Appendix K

STUDY NOTIFICATIONS AND CORRESPONDENCES

**Comments Received –
Notice of Study
Commencement**

OVERLAY MAP - INTERCHANGE OPTION 1

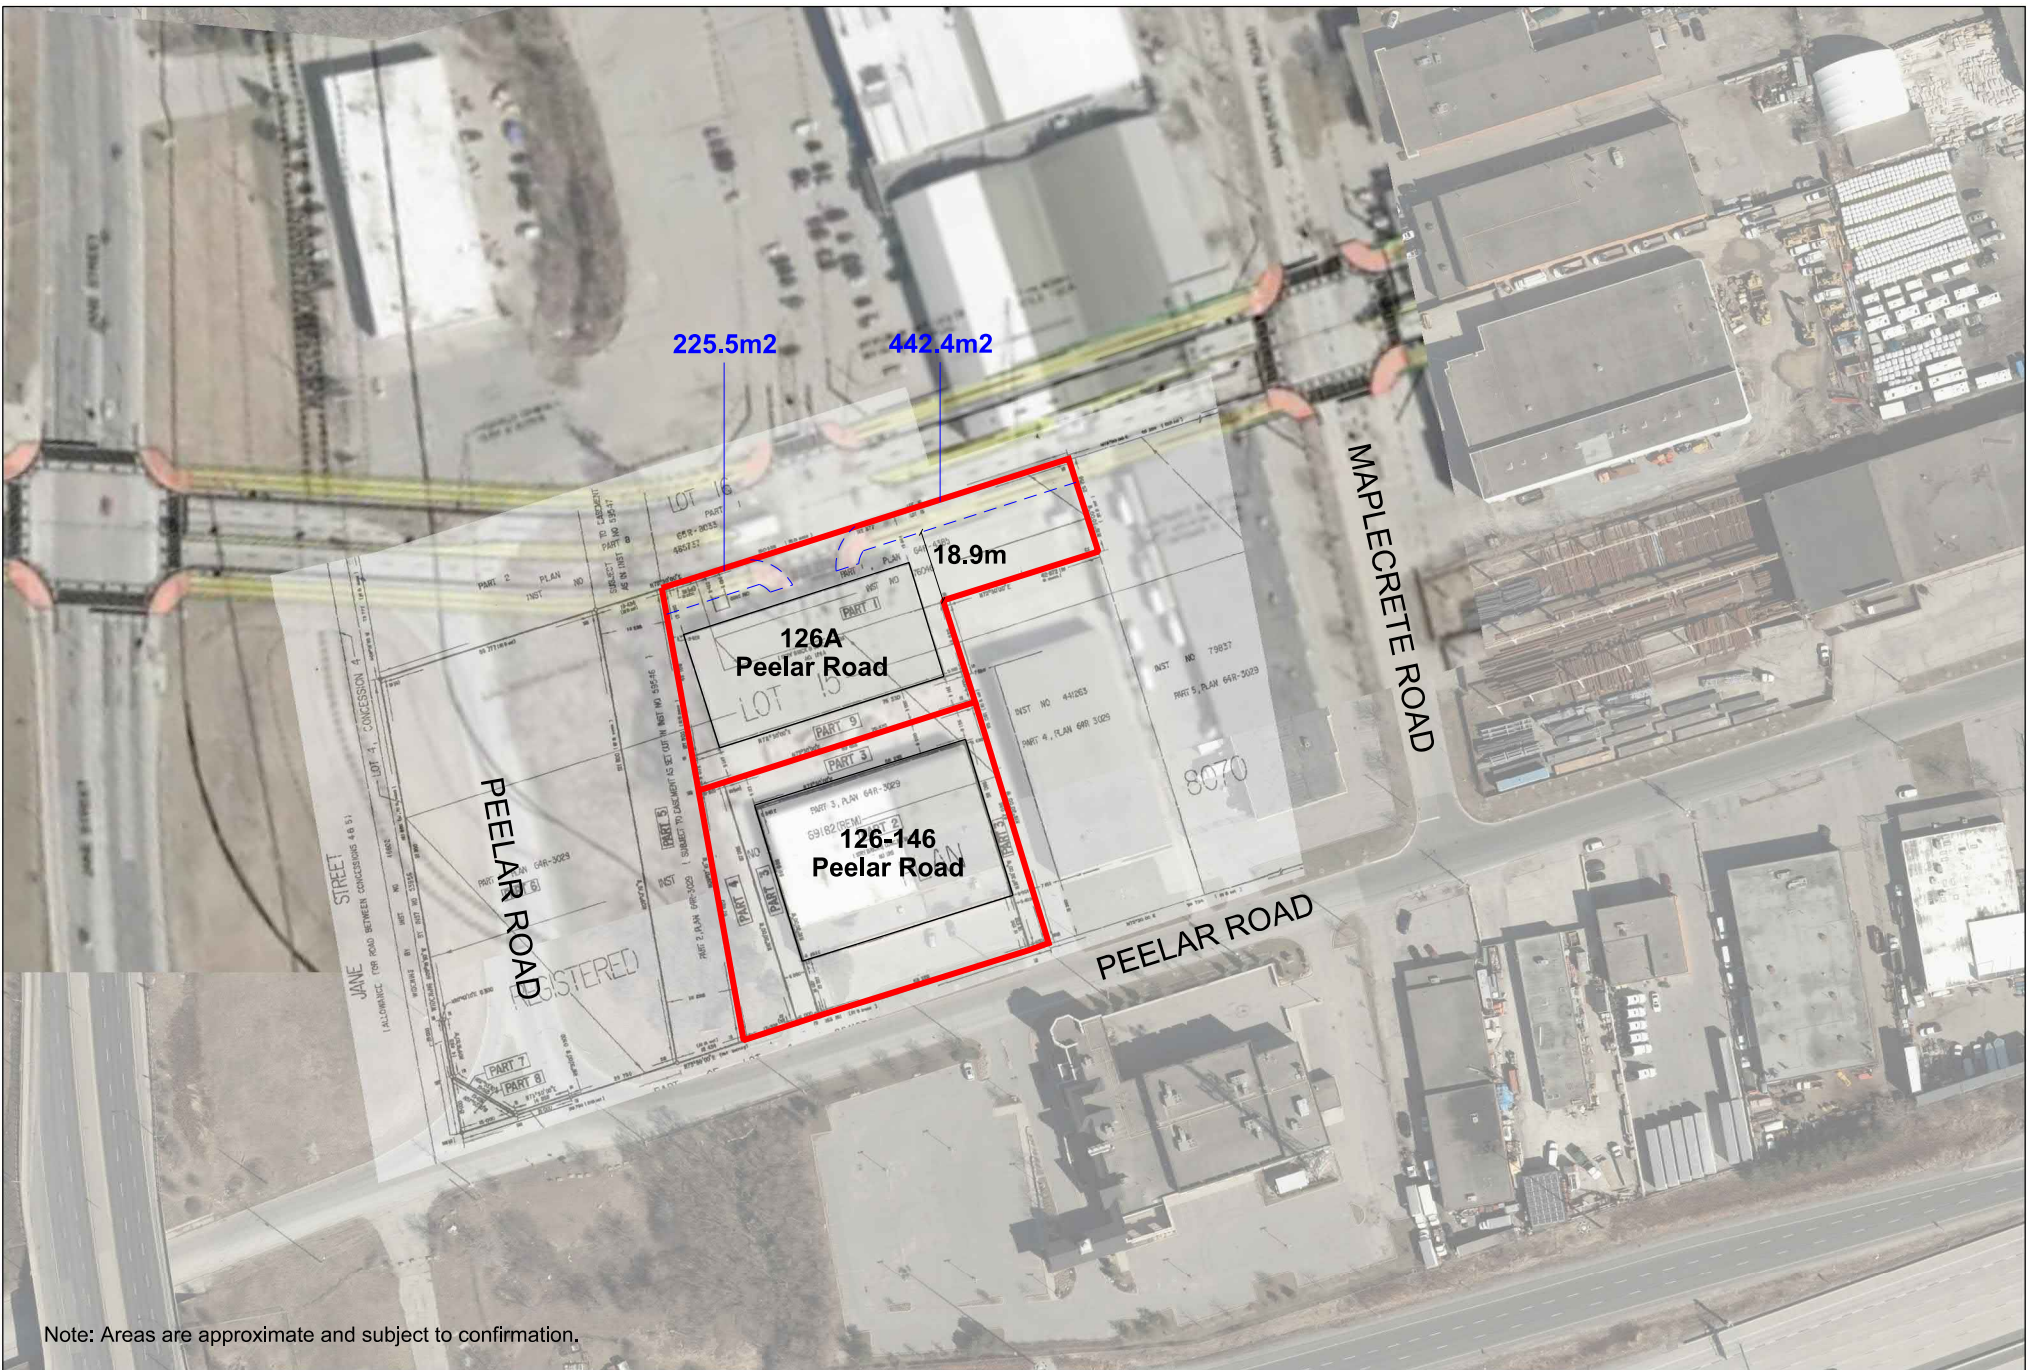
The VMC Secondary Plan currently has a significant impact on our client's lands. A considerable portion of the subject properties, on the west side, has been designated as parkland and is proposed as part of the Black Creek Greenway, as indicated on Schedule C – Street Network and Schedule D – Major Parks and Open Spaces of the most recently approved version of the VMCSPP in January 2017. This area is more than 30% of the total combined area of subject properties and will limit the future development opportunities on the site.

A north-south local street has also been proposed on Schedule C of the VMCSPP that bisects the subject properties. Of note, the subject properties are identified as *Area I* on Schedule K and are subject to site-specific policy 9.3.11 part b, which indicates that the need for location and alignment of the north-south local street (within the Area I) will be determined following the Black Creek Renewal EA and be subject to the development application review process, to the satisfaction of the City in consultation with York Region.

Based on this preliminary analysis, Option 1 is the preferred option for the extension of Interchange Way from Jane St to Creditstone Rd. This option has a minimal impact on the existing operation of the subject properties for the current in-place industrial lands uses. In addition, any land dedication requirements on the Pandolfo/Blackthorn lands can be mitigated through a reallocation of density on their lands in accordance with the policies of the VMC Secondary Plan.

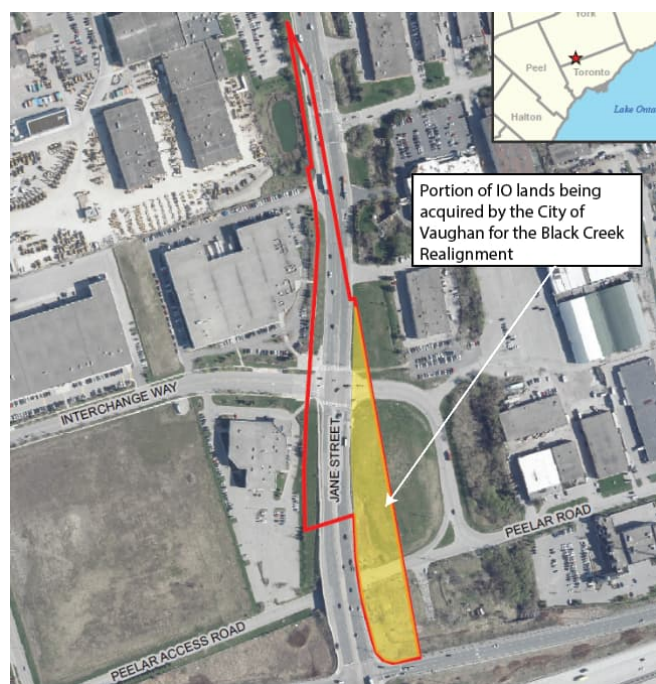
Thank you for including IO in the consultation for the Class EA Study for the Extension of Millway Avenue and Interchange Way. Based on the most recent presentation, it appears that all proposed alignments for the Interchange Way extension will include road improvements over lands that are managed by IO, on behalf of MOI. It should be noted that a portion of these lands will be sold to the City of Vaughan to accommodate the Black Creek Realignment (currently in negotiations). With that being said, IO has no comments regarding the proposed alignment as we suspect these lands will no longer be under our management when the road is extended.

IO will be recommending that the remainder of the MOI-owned lands be transferred to the Region of York, as they are mainly occupied by Jane Street, an existing Regional Road. The image below shows the IO-managed lands outlined in red and the portion that will be sold to the City for the Black Creek Realignment in yellow.

Figure 2

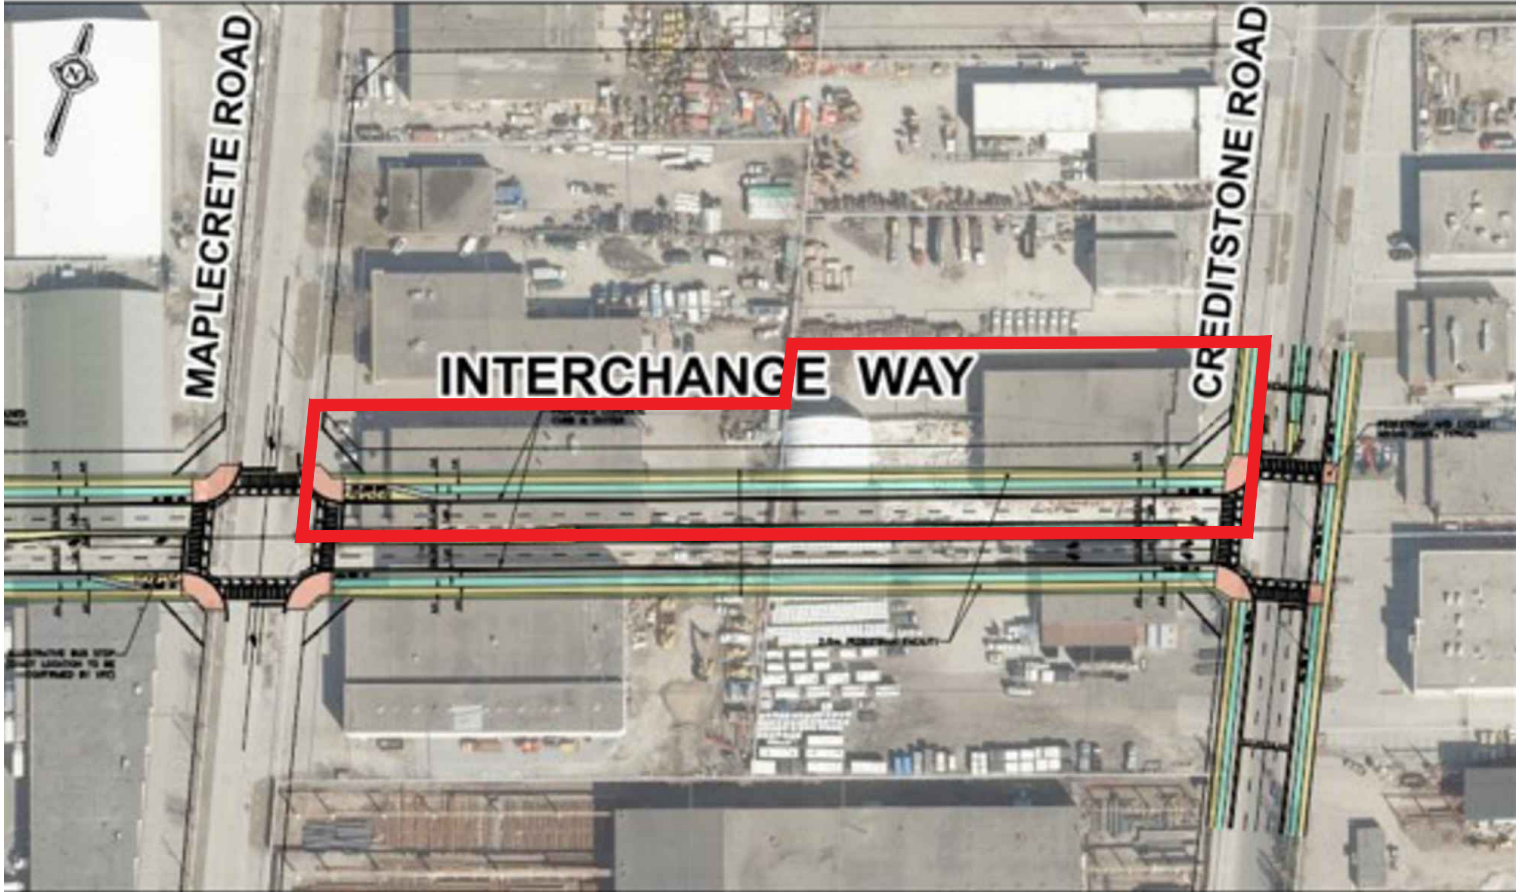
It is understood that the EA is at Stage 3 of the process, which entails the evaluation of alternative designs, for both Millway Avenue and Interchange Way, according to their relative advantages and disadvantages. This submission focuses on the Interchange Way given its proposed location in relation to the Buttarazzi Lands. 3 alternative designs have been considered for the Interchange Way, with the preferred alternative design being Option 2, which has a right-of-way (ROW) width of 33 metres. This design option directly overlaps with the Buttarazzi Lands as shown on **Figure 2**.

Overall, the EA process should consider the balance between the positioning of the road and the developability of lands. As previously highlighted, the preferred design option (Option 2) overlaps with the Buttarazzi Lands. This design option takes a total of approximately 4,400.1 m² (42%) from the lands and, as a result, there will

INTERCHANGE WAY AND MILLWAY AVENUE TYPICAL SECTION

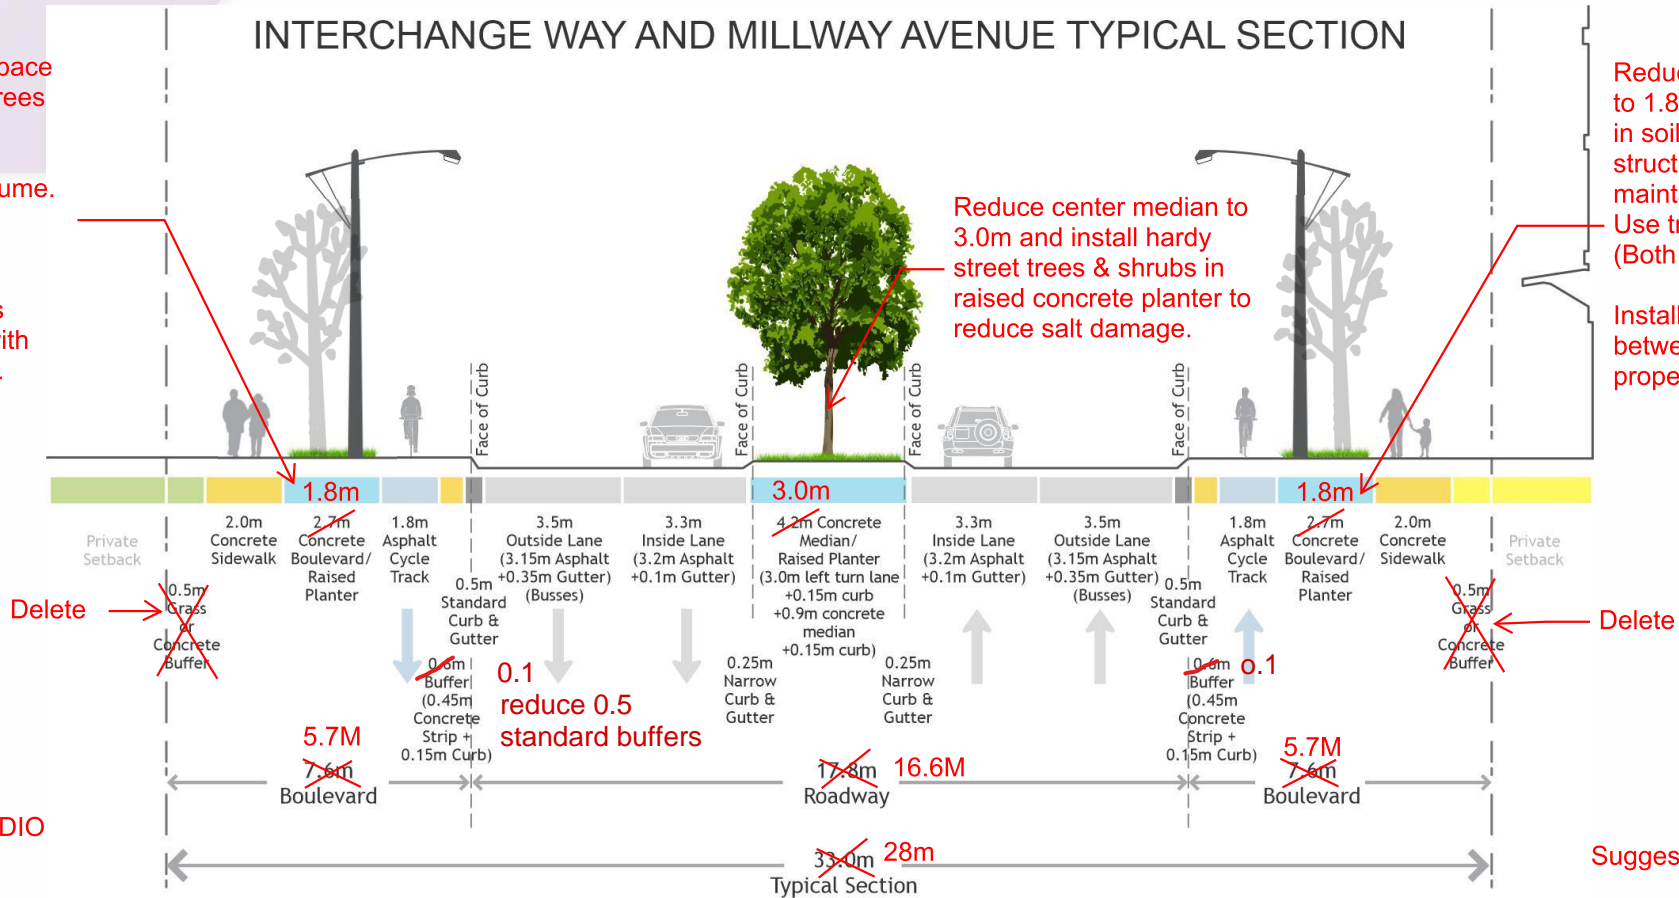
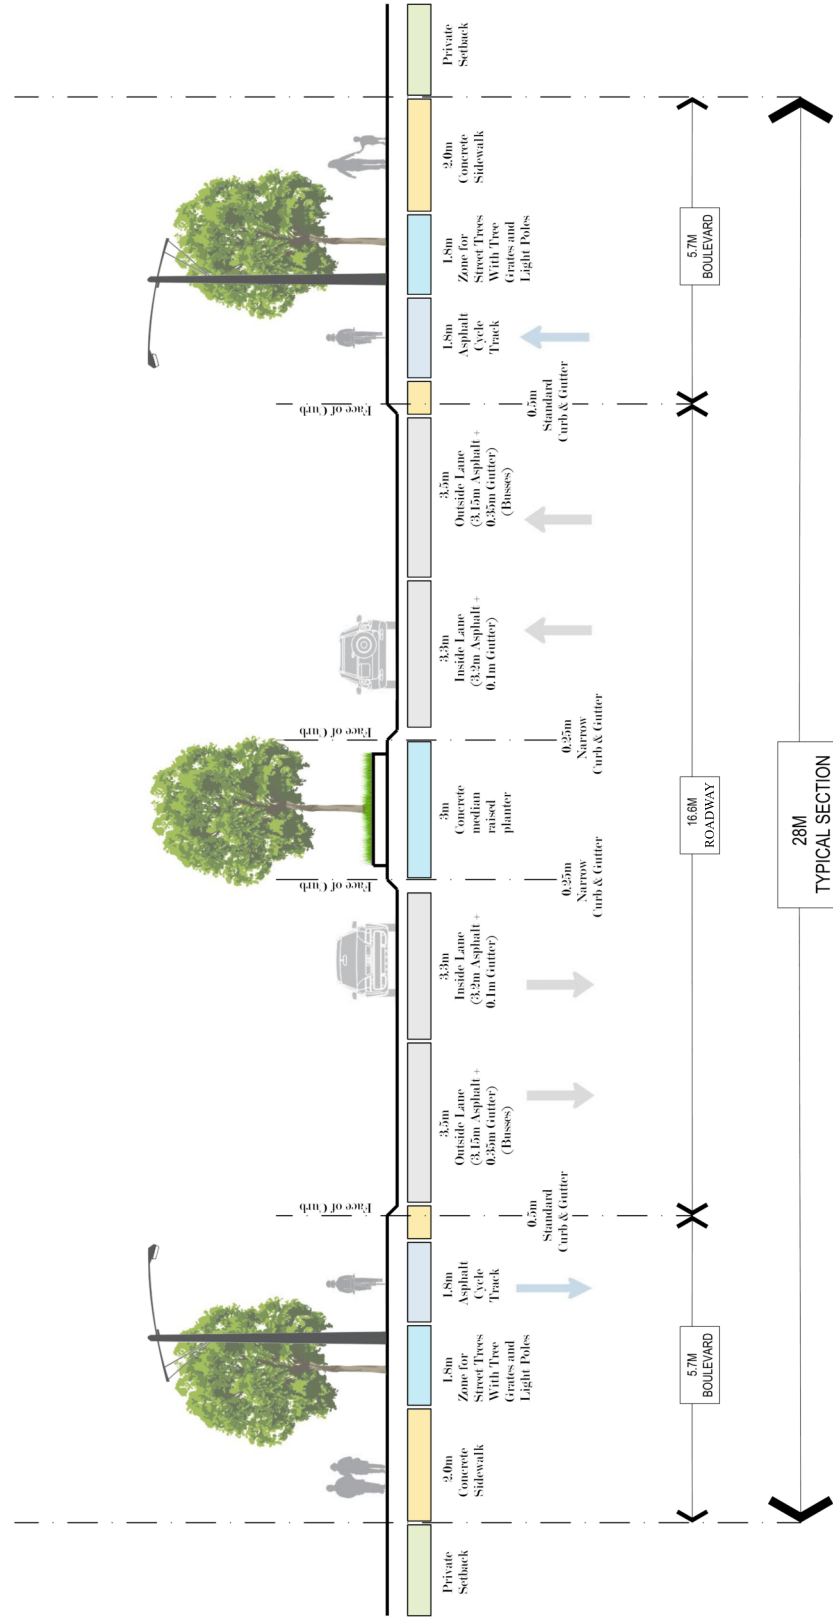
Reduce green space to 1.8 m. Plant trees in soil cells or structural soil to maintain soil volume. Use tree grates (Both Sides)

Install light poles between trees with proper setbacks.

Delete

Delete
